**Comments on the Draft: *Assessment Methodology for the Preparation of The 2014 Integrated Water Quality Monitoring and Assessment Report, and The 2016 Water Quality Monitoring and Assessment Report, authored by the Arkansas Department of Environmental Quality (ADEQ)***

**JoAnn M. Burkholder, Ph.D., 15 March 2016**

**Figure 3.** Comparison of U.S. EPA-recommended protocols for setting numeric thresholds for nutrients (TN, TP – U.S. EPA 2000a,b), versus ADEQ's in the Report.

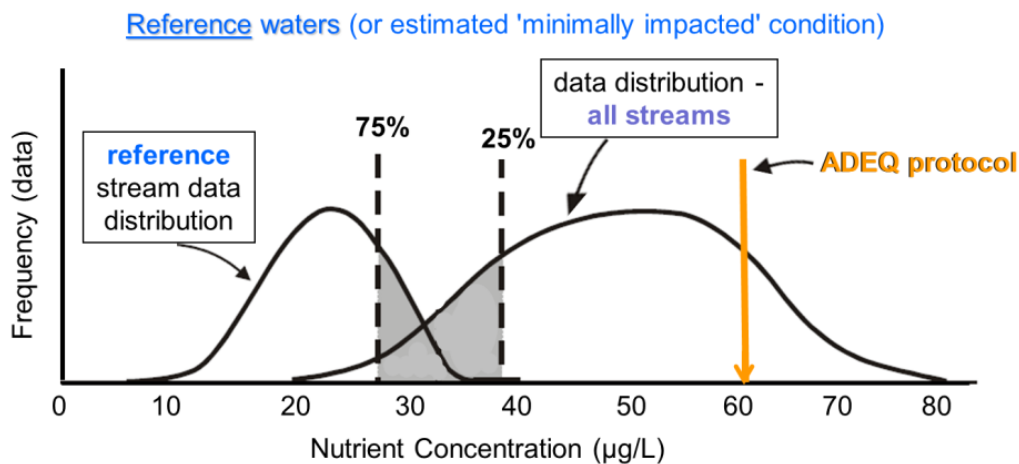
ADEQ has established a protocol which sets levels of excess TN and TP. Its protocol sets these thresholds much higher (that is, the thresholds are much less protective) than the procedure

recommended by U.S. EPA's (2000a,b). The U.S. EPA (200a,b) recommends that if true reference (pristine) sites are available for a given ecoregion within a state, the state should use the 75<sup>th</sup> percentile of data collected in the past ~decade from the reference sites as the threshold numeric nutrient (TN, TP) criteria. If true reference waters can no longer be found in the ecoregion, the U.S. EPA recommends that to prevent deviation from "minimally impacted" water quality, the state should use the 25<sup>th</sup> percentile of all data, that is, data available (past ~decade) from all streams in the ecoregion within the state in setting numeric nutrient (TN, TP) criteria:

**75<sup>th</sup> percentile of all streams data – ADEQ protocol, not protective; much higher nutrient concentrations are deemed “acceptable.”**

Thus, scrutiny of ADEQ's "Assessment Methodology for Nutrients" shows that, rather than following U.S. EPA's (2000a,b) protective recommendations, ADEQ designed a protocol for wadeable streams and rivers which begins by assuming that **much higher** TN and TP concentrations are "acceptable:" Moreover, if these high concentrations are not exceeded, then ADEQ simply assumes that there is no nutrient-related impairment. If the high concentrations ADEQ has selected are exceeded, however, the agency does not evaluate the waterbody as impaired. Rather, ADEQ follows a set of steps that are biased against finding impairment.

- The ADEQ protocol for excess TN and TP in wadeable Arkansas streams should be set at the 25<sup>th</sup> percentile of all streams data within a given ecoregion following U.S. EPA recommendations, rather than at the much-less-protective 75<sup>th</sup> percentile.
